Subject: CERTIFICATE OF COMPLIANCE NO. 9297 FOR THE MODEL NO. TRAVELLER PACKAGE, RESPONSE TO SECOND NRC REQUEST FOR ADDITIONAL INFORMATION (RAI)

Enclosed are the change pages that make up revision 2 to the Traveller SAR. A summary description of the major revision items is presented for each section.

**Application for Certificate of
Compliance for the
Traveller PWR Fuel Shipping
Package**

Revision 2: February 2005

Figure 2-63A Predicted Temperature and Foam Density Effect on Outerpack/Drop Pad Interface Forces (9m Vertical Drop onto the Bottom End of the Package)

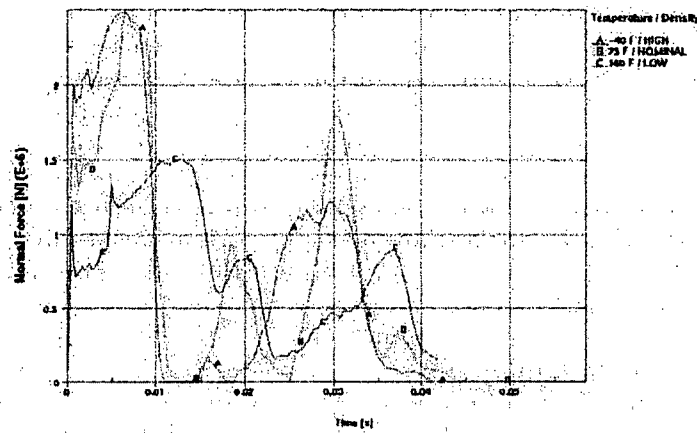
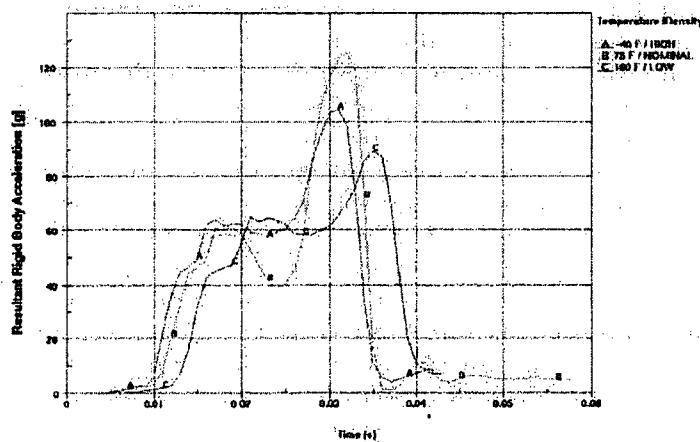
- Removed reference to borated aluminum.
- Corrected grammatical and typographical errors.
- Corrected cross-reference errors.
- Revised Section 2.12.3 to place appropriate emphasis on FEA results.
- Replaced Figures 2-89 and 2-119 with correct annotations for axial and vertical response quantities
- Reconciled the peak acceleration values listed in Table 2-30 with those displayed in Figure 2-91.
- Provided reference or justification for the use of bolt interaction equations
- Provided justification for assertion that temperature and variation in form density due to manufacturing tolerances have only minor effect on the drop performance of the Traveller package.

Temperature/foam tolerance effects for the 9 meter vertical drop onto the bottom nozzle end of the package were evaluated for the three previously noted conditions. Both predicted outerpack/drop pad force histories and fuel assembly accelerations were compared as shown in Figures 2-63A and 2-63B.

Figure 6-18 Sensitivity Study of Boron Content for Traveller XL Package Array

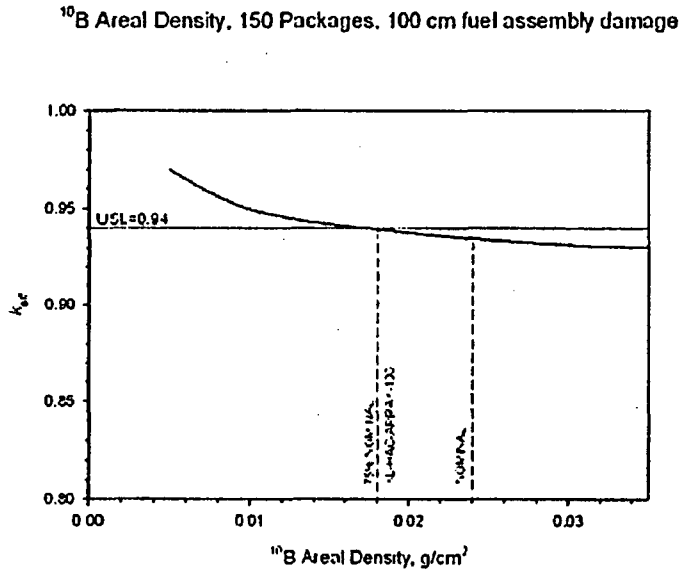
- Re-ran models using actual HAC model rather than earlier version.
 - The actual HAC model included replacement of borated aluminum with BORAL
 - Changing areal density from 0.0188 g/cm^2 to 0.0180 g/cm^2 .

The analysis included a sensitivity study of boron content in the neutron absorber. The sensitivity to ^{10}B areal density is evaluated for a package array with 100 cm fuel lattice expansion. Figure 6-18 shows k_{eff} versus ^{10}B content for BORAL. The ^{10}B effectiveness does not diminish significantly until the areal density decreases to approximately 0.010 gm/cm^2 . As can be seen in

Figure 6-18C Clamshell Up and Rotated Model

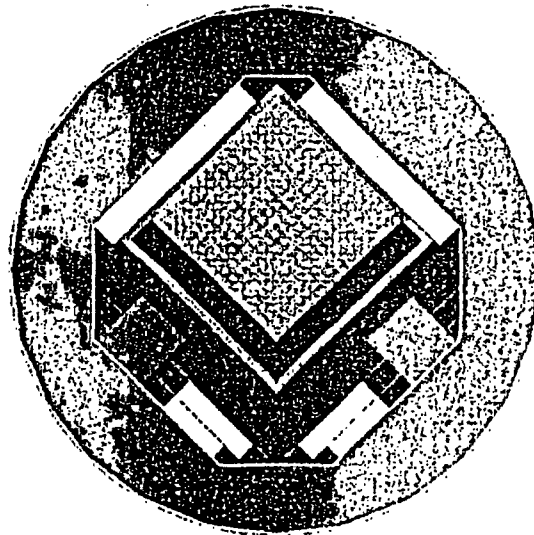
- Corrected inconsistency with regard to moderation configuration for array and individual package.
- Performed sensitivity study to evaluate effect on system k_{eff} if shock mounts were to fail and the clamshell were to relocate inside the outerpack.

Nevertheless, calculations were performed to show the effect on keff if all shock mounts were destroyed. The results show no change in keff for the clamshell down model, and a slight increase for the clamshell up and rotated model. Table 6-19A below gives the results. Figure 6-18C shows the clamshell up and rotated model. Table 6-39F gives the input deck for the clamshell up and rotated model.

Figure 6-39 Interspersed Moderation Curves for Rod Box and Rod Pipe

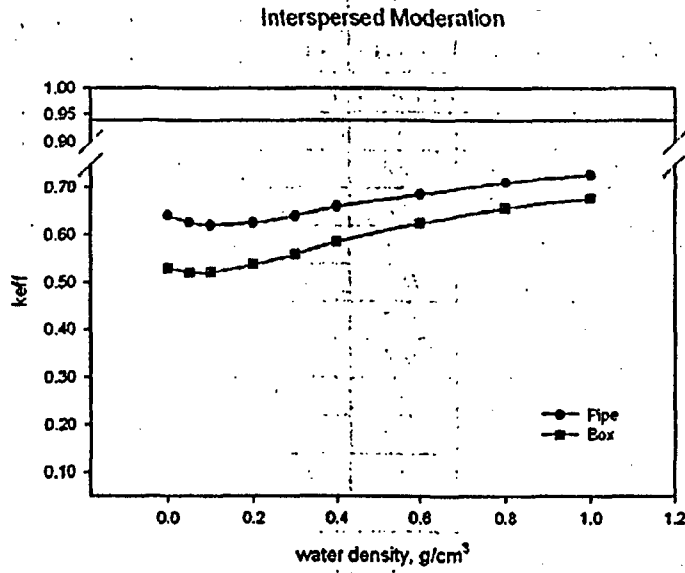
- Included precise modeling of moderator blocks.
 - Included input decks which were inadvertently omitted in Rev 1.
 - Performed sensitivity analysis for varying water density for interspersed moderation for infinite array cases.

After plotting curves to find approximate maximum k_{eff} values for the pitch/diameter combinations, two array cases were selected, one each for the rod box and rod pipe. These were analyzed to determine the effect on k_{eff} of varying the interspersed moderation water density. These results are shown in Figure 6-39.
